**ANGEL PLACE
LEVEL 8, 123 PITT STREET
SYDNEY NSW 2000**

RESPONSE TO REQUEST FOR ADDITIONAL INFORMATION – ALTERATIONS AND ADDITIONS TO MERIDEN SCHOOL (SSD-9692)

Figure 1 – Location of the rear fence to be made good

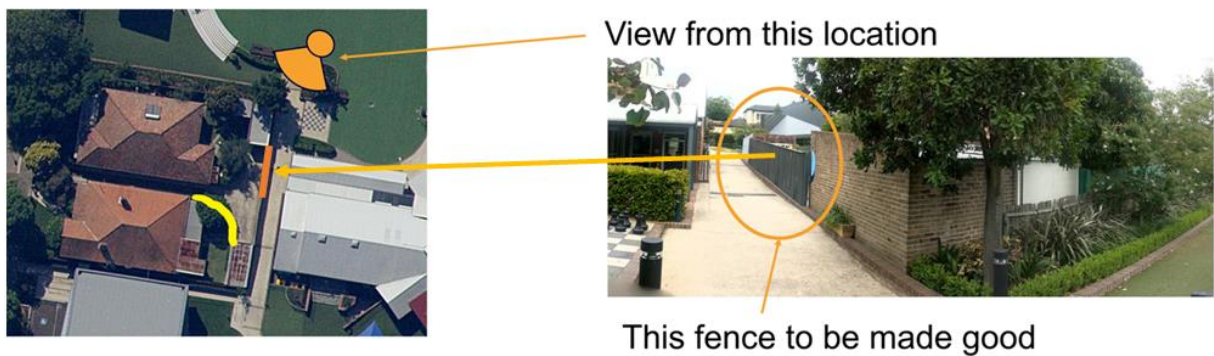
2. If making good works to the 'existing' timber fence is no longer proposed, confirmation that the predicted noise levels from the use of the proposed adjoining playground do not rely on the upgraded 1.8 metre high fence in order to comply with the 43 dBA project noise trigger level.

Response: A rear timber fence is located along the eastern boundary of 2 Vernon Street (refer to Figure 1).

It is proposed to improve this rear fence (e.g. re-nailing fence palings, replacement of some palings etc.) to ensure amenity can be further enhanced. The location of the fence to be made good has been corrected in the Landscape Plan (refer to Figure 2).
